Review of Available Water Temperature Data and Thermal Plume Characterizations related to the Merrimack Power Station in Bow, NH

December 11, 2017

1.0 Introduction

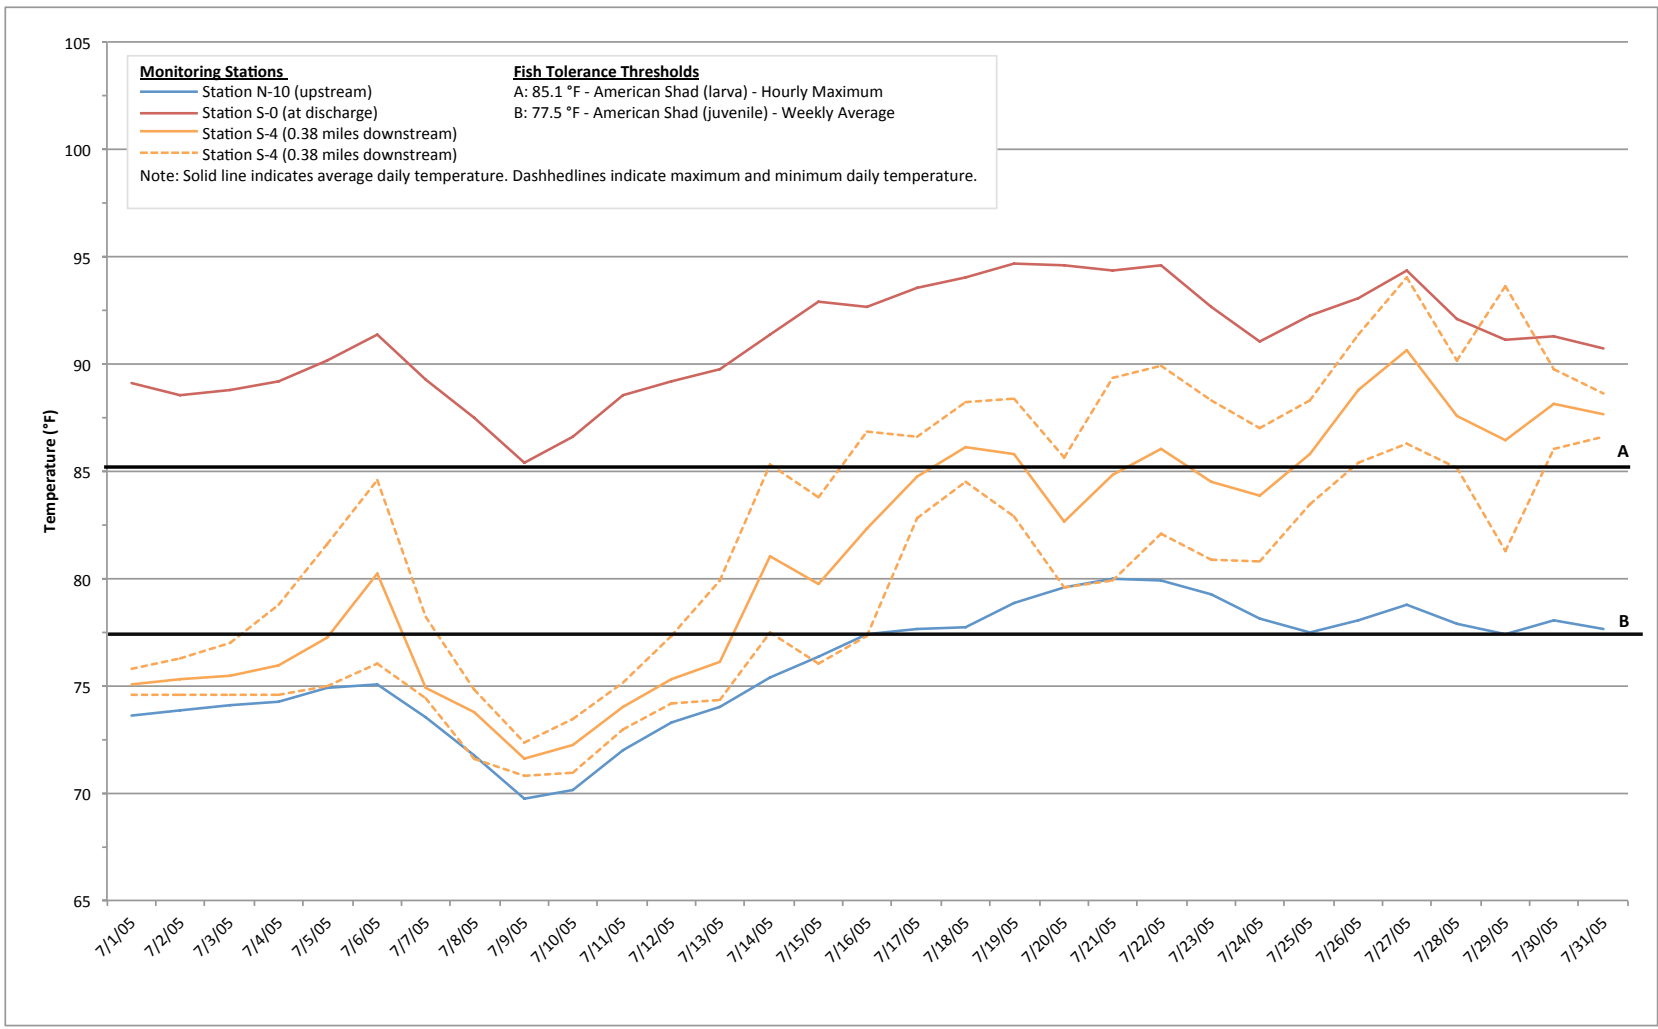
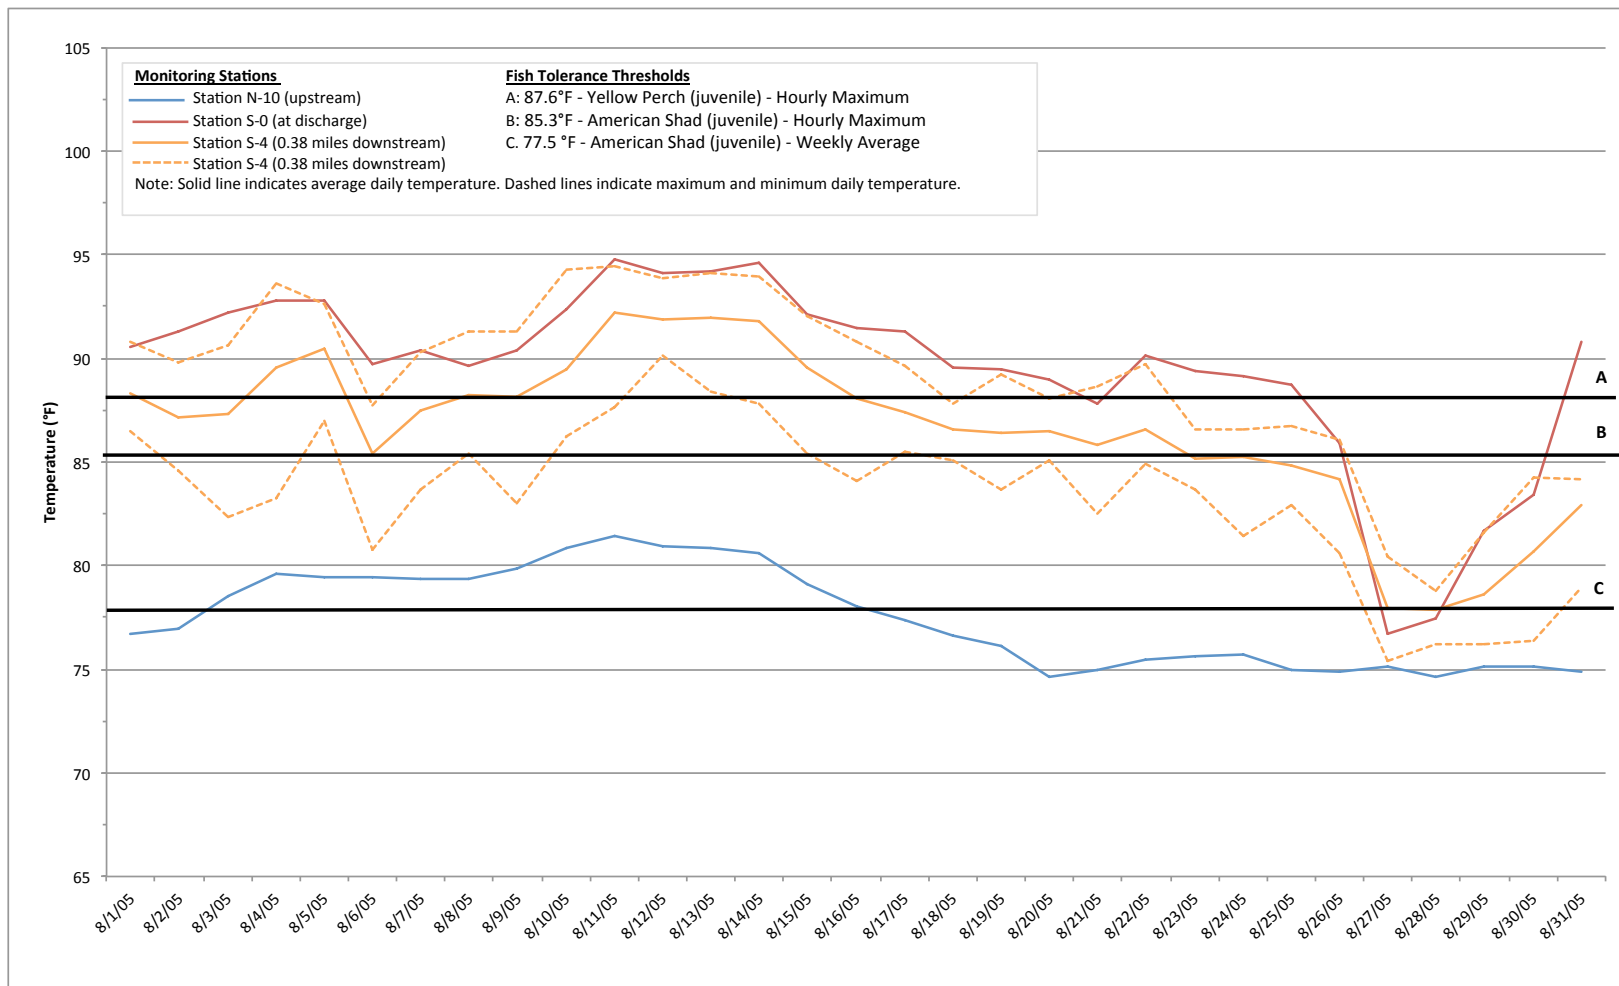
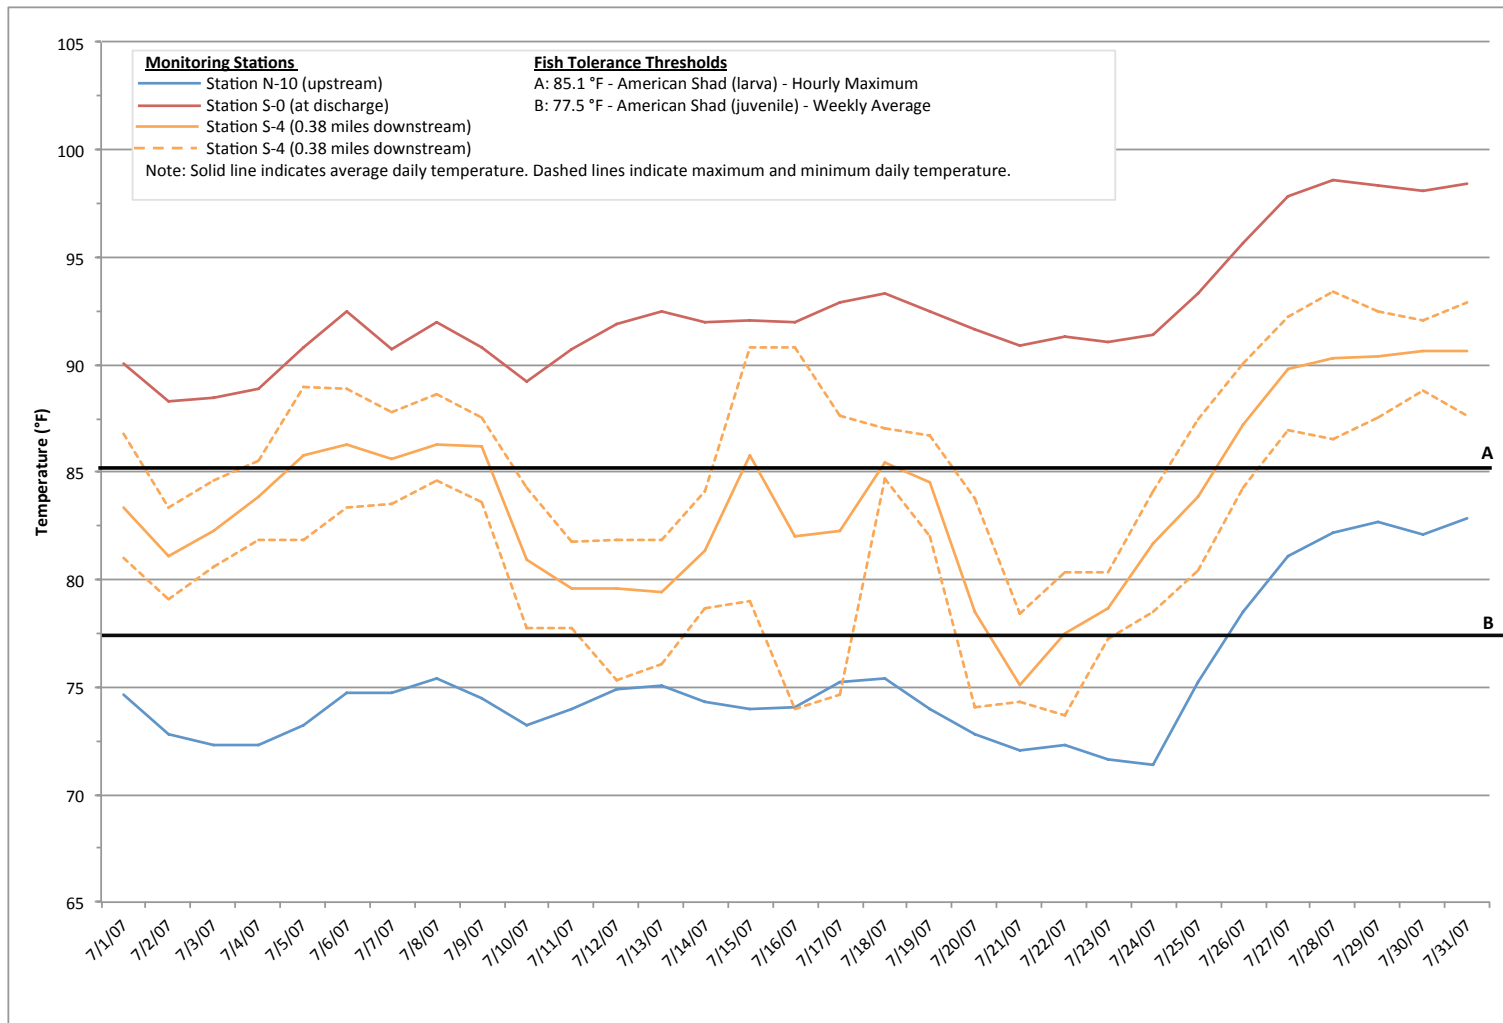
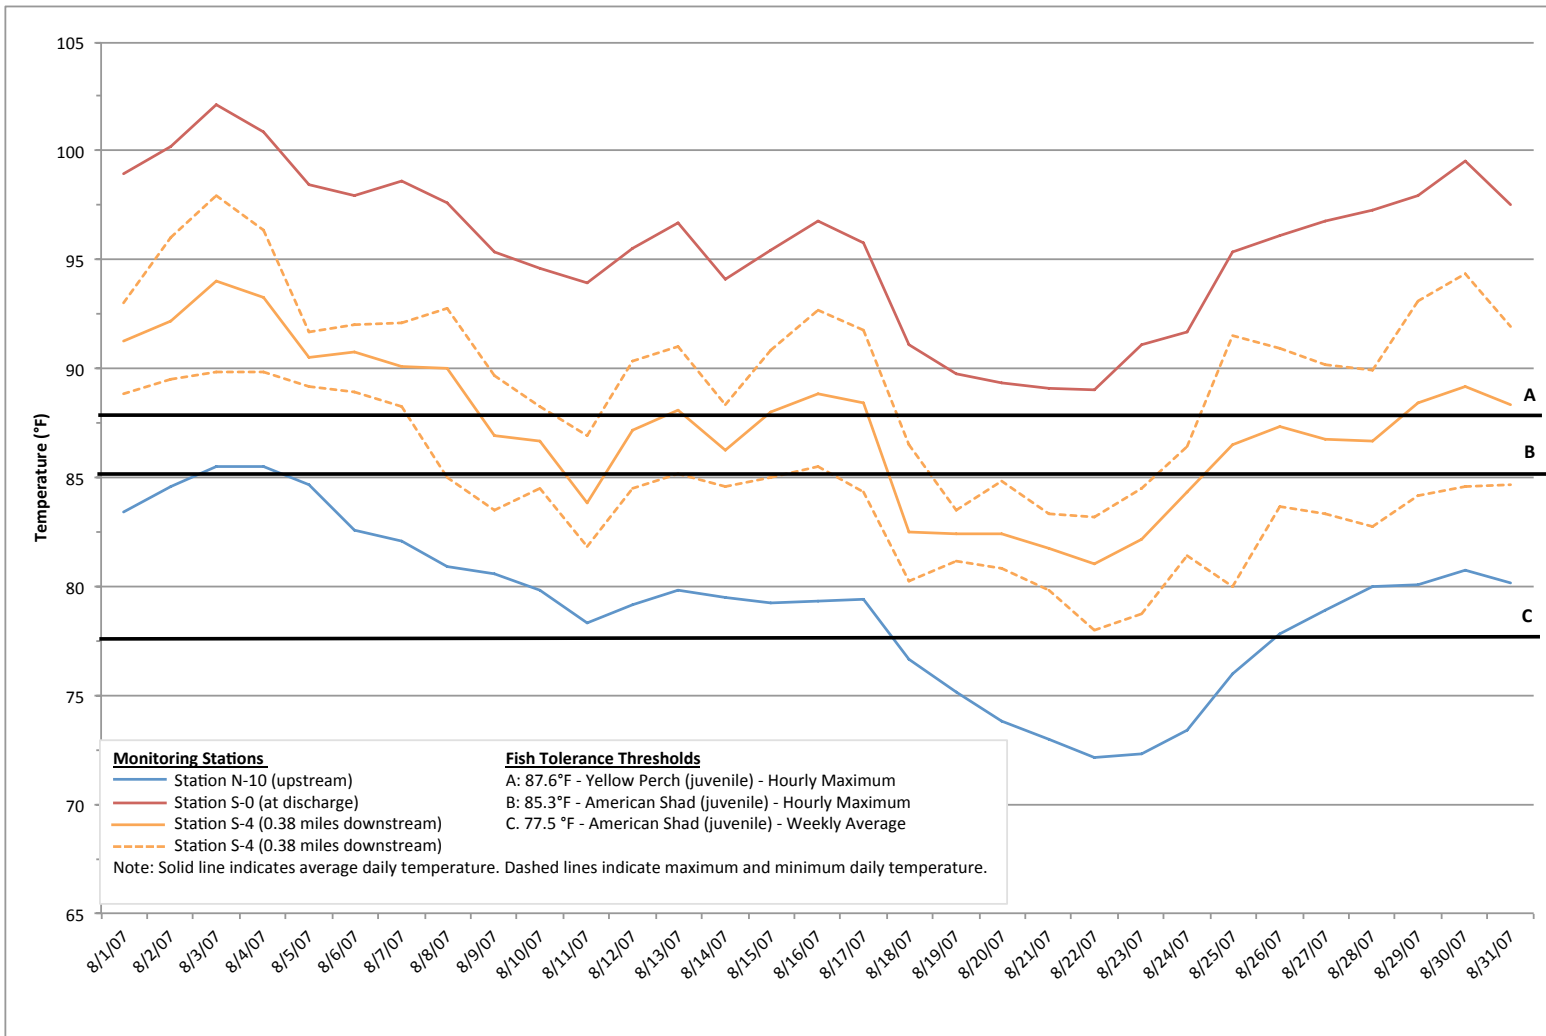
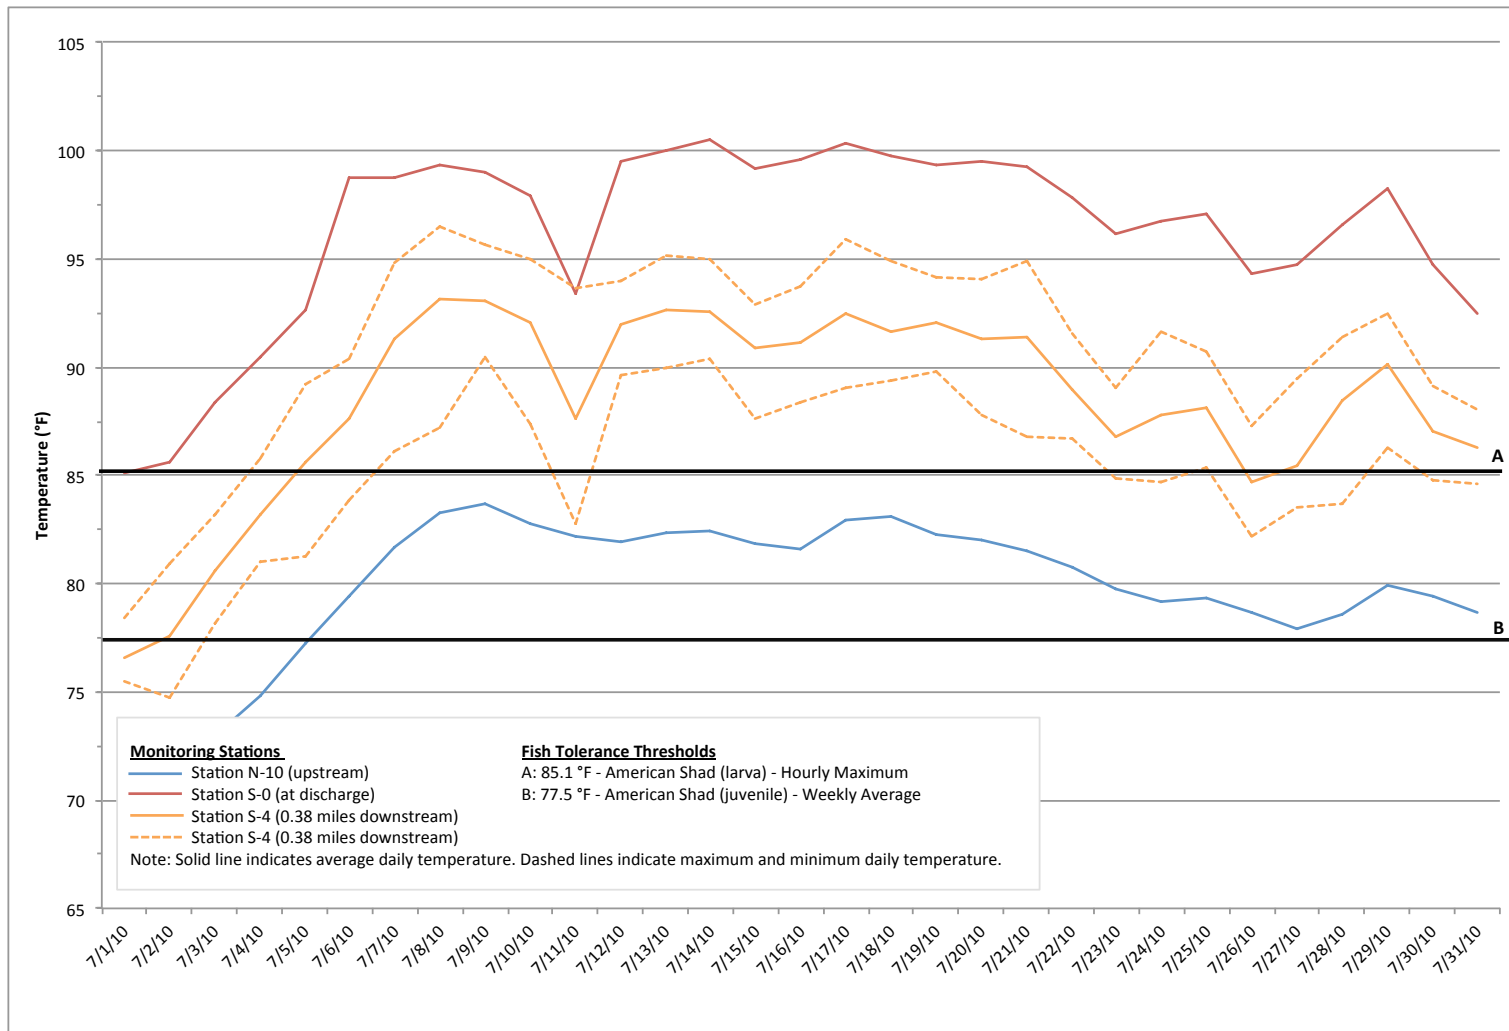
Water temperature measurements and selected applicable fish tolerance thresholds are presented for July and August of 2005, 2007, 2010, and 2012 in Figures 6 through 13. These figures show exceedances of acute and average weekly fish tolerances for extended time periods at Merrimack River stations.
